Model: Kaiser1	Date: 29-Feb-00	No.: RH306001a
----------------	-----------------	----------------

Subject: ROM History (Kaiser 1)		Prepared by: M. Mano	
From: Technical Services Dept., GTS Division			
Classification:	<input type="checkbox"/> Troubleshooting <input type="checkbox"/> Part information <input type="checkbox"/> Action required		
	<input type="checkbox"/> Mechanical <input type="checkbox"/> Electrical <input type="checkbox"/> Service manual revision		
	<input type="checkbox"/> Paper path <input type="checkbox"/> Transmit/receive <input checked="" type="checkbox"/> Retrofit information		
	<input type="checkbox"/> Other (       )

Firmware history for the Kaiser1 (USA Model)

[Fig. 1]

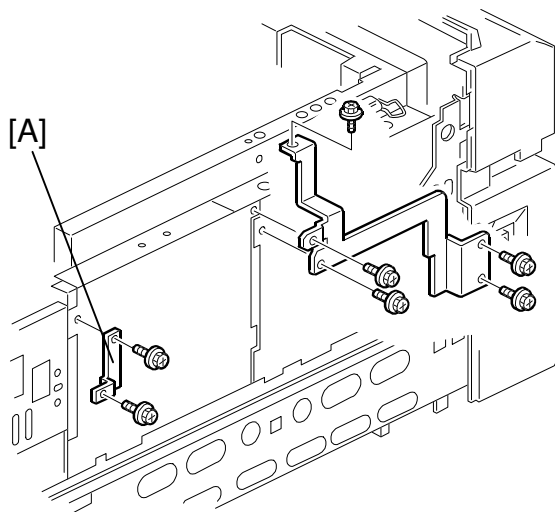
The PIF option grounding plate [A] (P/N: H3064662) in the following 15 units will bend slightly when you attach it, as shown in figure 2.

However, the plate will function normally and the slight bending will not affect the operations of the printer unit or mainframe in any way.

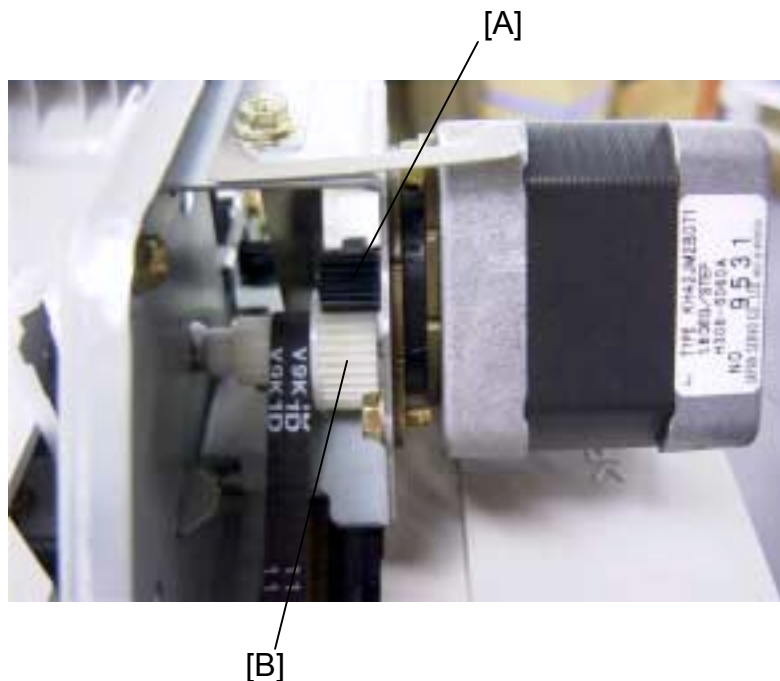
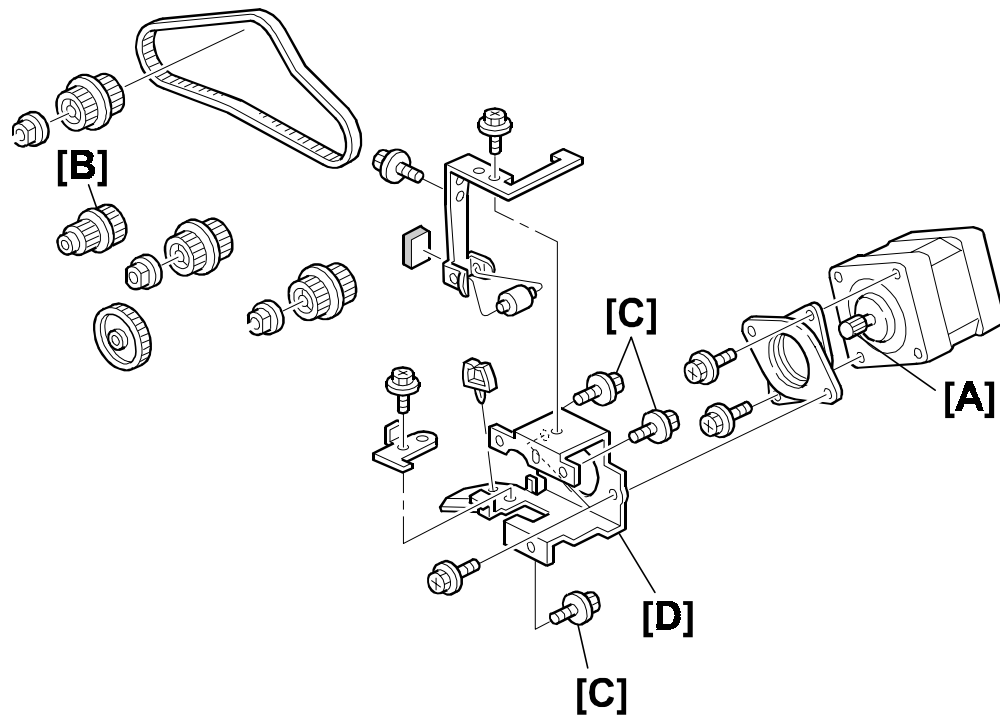
A squeaking sound can be heard coming from the ADF unit.

Vibration of the ADF motor gear [A] and ADF rear slow down gear [B] as shown below.

In the field, please re-tighten the 3 screws [C] (see the next page) that secure the ADF motor bracket [D] to the ADF unit. This will ensure that the 2 gear shafts are parallel.

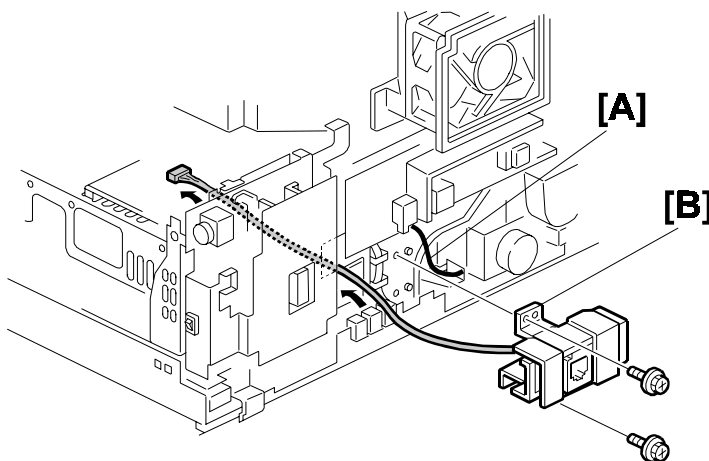
When the following option(s) are installed, the paper end sensor harness [A] may be pinched between the mainframe and the bracket [B].

If the harness [A] is pinched, a number of symptoms can occur such as:

When installing the bracket for the options mentioned above, please make sure that the harness remains to the right of the bracket and does not get pinched.

For the N. America model, the routing of the harness has been changed from the beginning of March 2000 production.

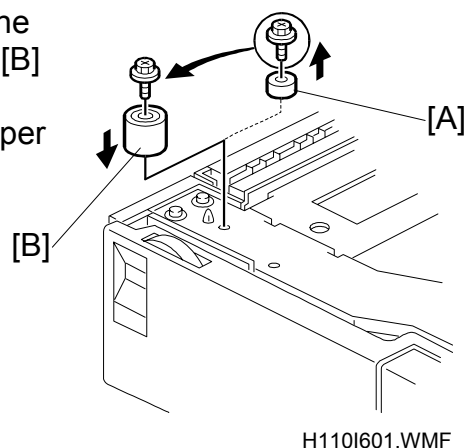
A note has been added to step 1 of the PFU installation procedure.

**NOTE: Remove the 2 tie-wraps securing the paper feed rollers (located under the red tag).**

■ ***If you do not remove the 2 tie-wraps, the PFU cannot properly feed the paper.***

1. When the paper feed unit is installed just under the machine, change the small leg [A] to the big one [B] that is enclosed.

**NOTE:** Remove the 2 tie-wraps securing the paper feed rollers (located under the red tag).
